FAM-A-0095-A

# Change in the Nameplate and LOT Number for the FX5UC CPU Modules

Date of Issue
September 2024
Relevant Models
FX5UC CPU module

#### Nameplate

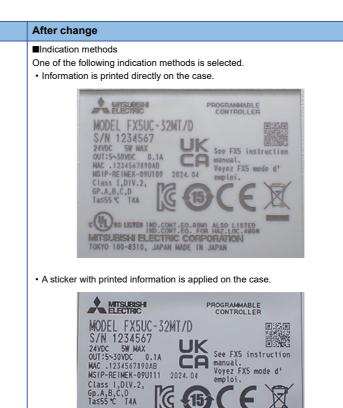
There will be two types of indication methods as follows.

A sticker with printed information is applied on the case.

#### LOT number

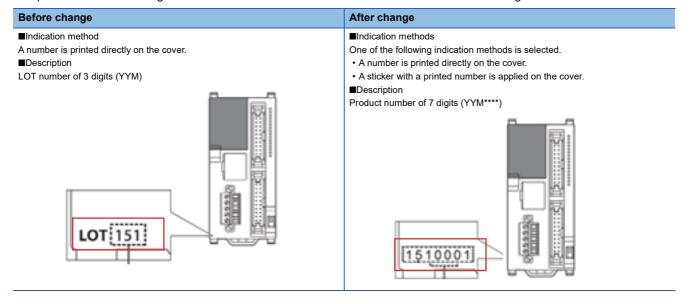
There will be two types of indication methods as follows.

The product number of 7 digits will be indicated on the cover instead of the LOT number of 3 digits.
